ADDENDUM NO. 01

Amendments to RFP/EPC Bidding Document for Engineering, Procurement and Construction (EPC) of Attabad Lake Hydropower Project (54 MW) Package-III: Electro-Mechanical Works

This Addendum No. 01 to RFP/EPC Bidding Document containing the following amendments to the EPC Bidding Document for Engineering, Procurement and Construction (EPC) of Attabad Lake Hydropower Project (54 MW) Package-III: Electro-Mechanical Works is issued pursuant to ITP 8.1 of Volume-I of RFP/EPC Bidding Document.

132 kV SWITCHYARD AC AUXILIARY SERVICES SYSTEM (TYPICAL)		SCALE
DATE : MARCH, 2023	DRAWING No. ALHPP-SY-0603	REV.

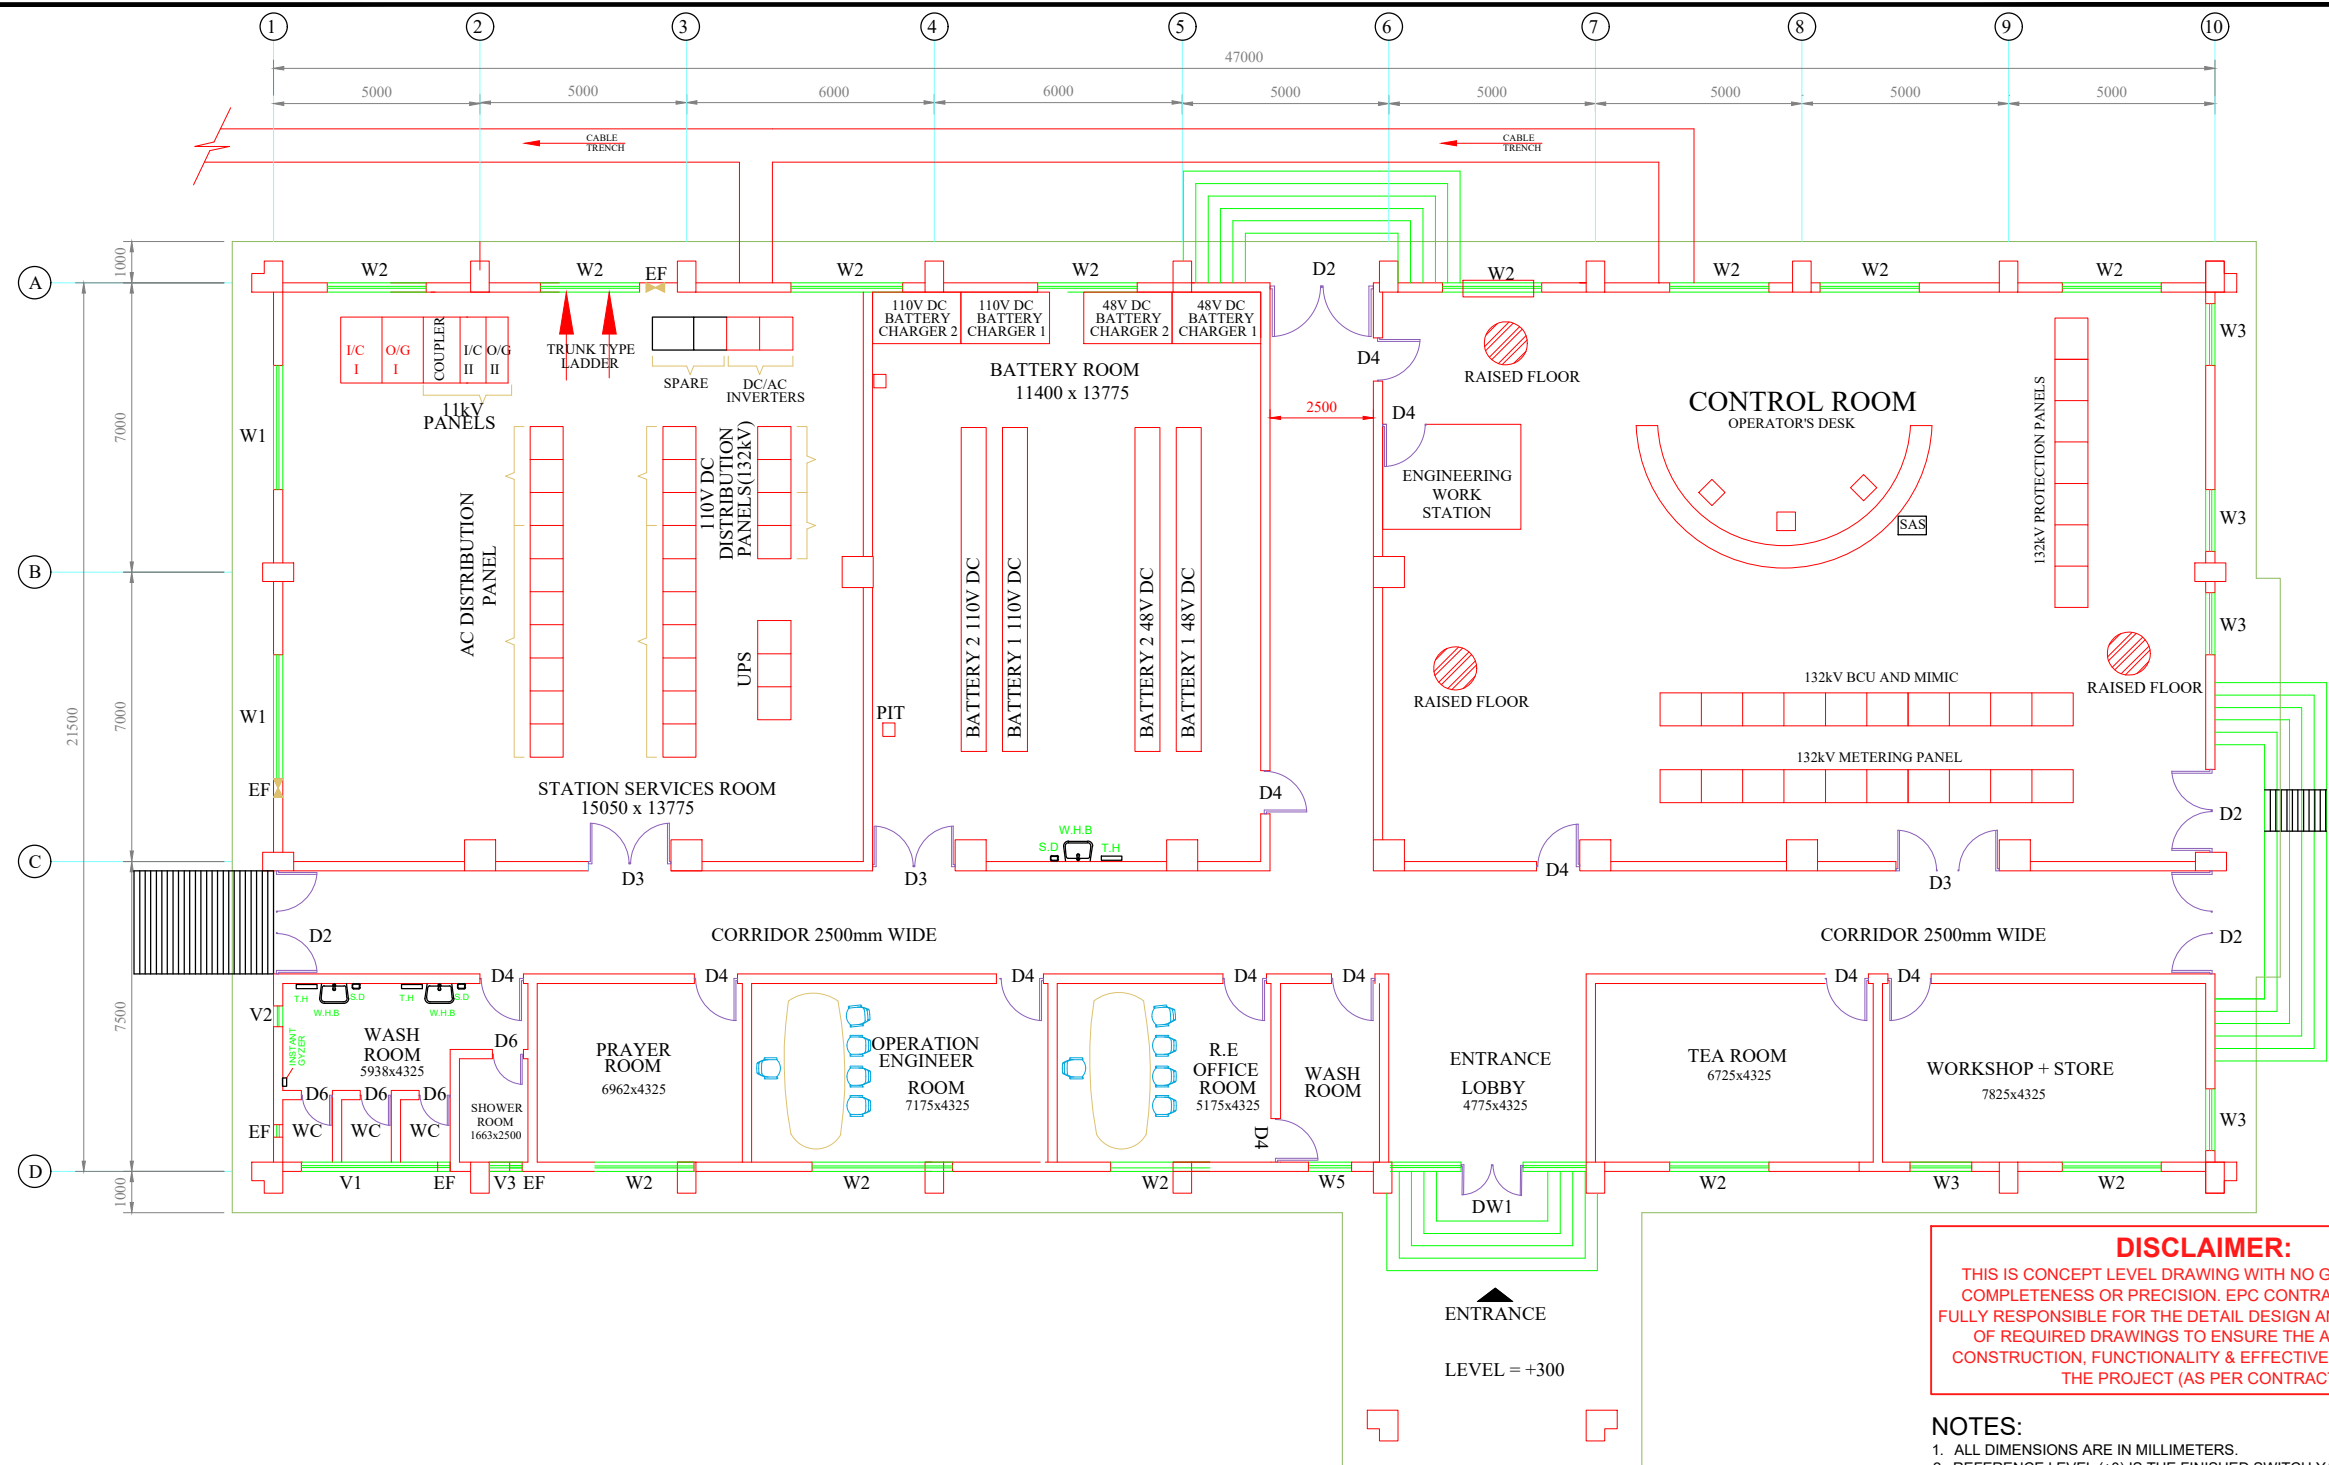
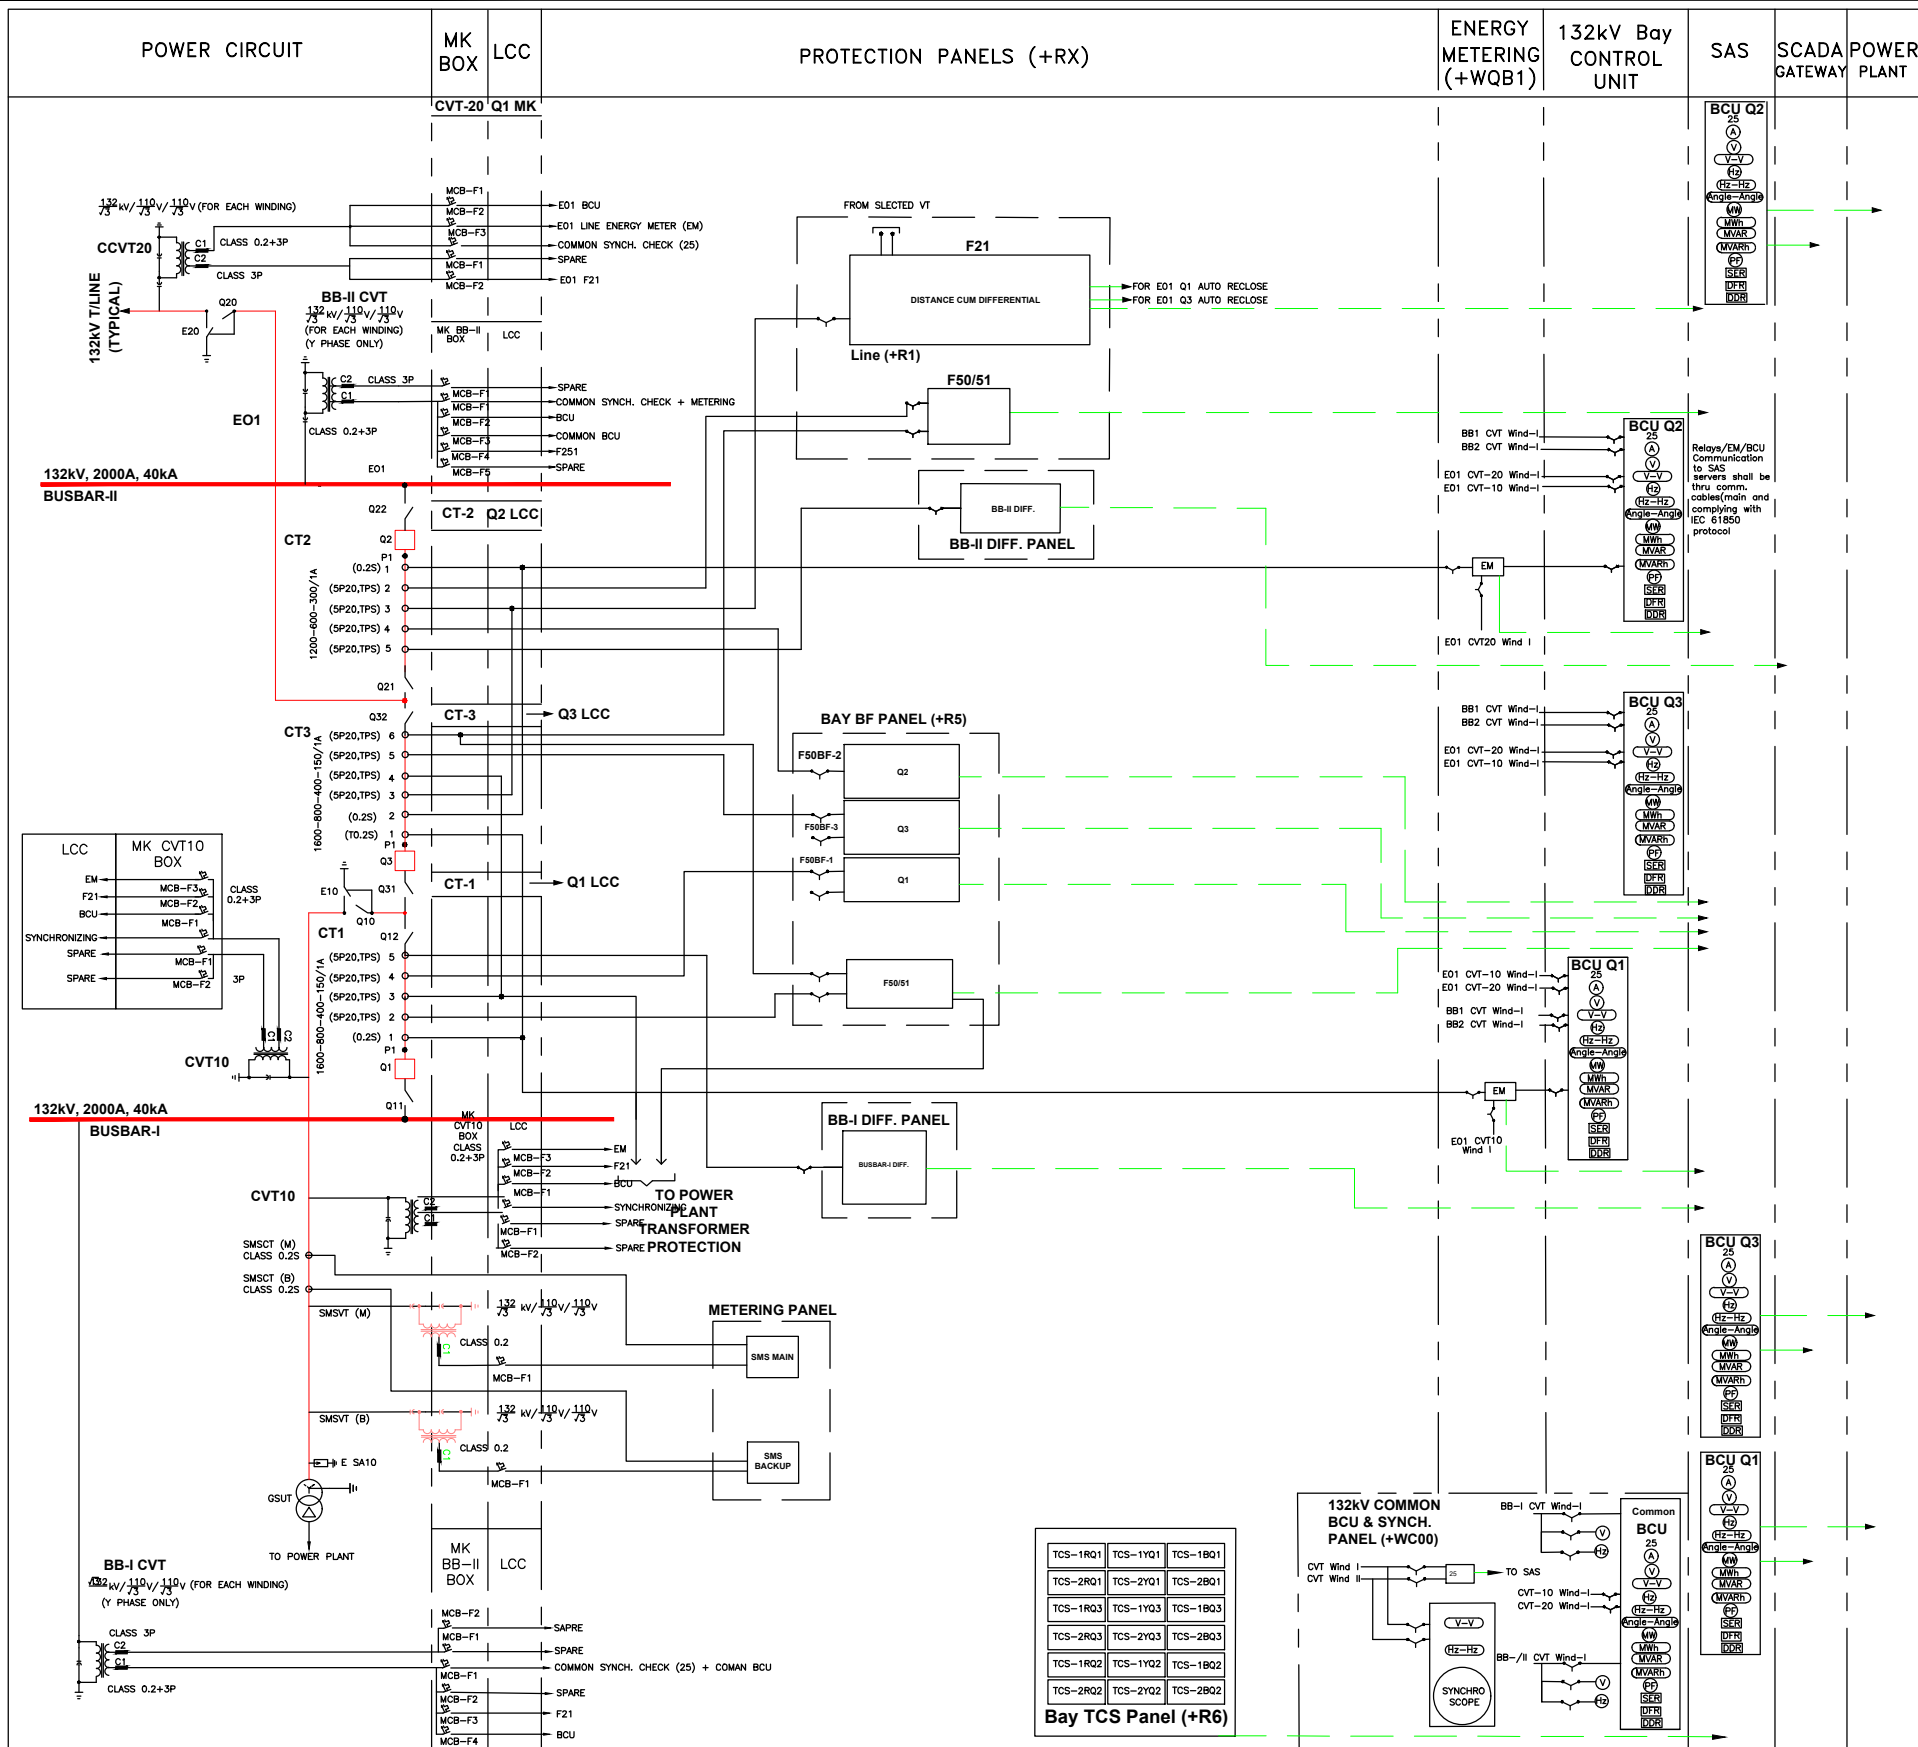
The above-mentioned Conceptual Drawings shall be substituted after deleting in their entirety of 132 kV Remote End Line Bays Conceptual Drawings in accordance with the Original Scope and shall be attached as **Annexure J**.
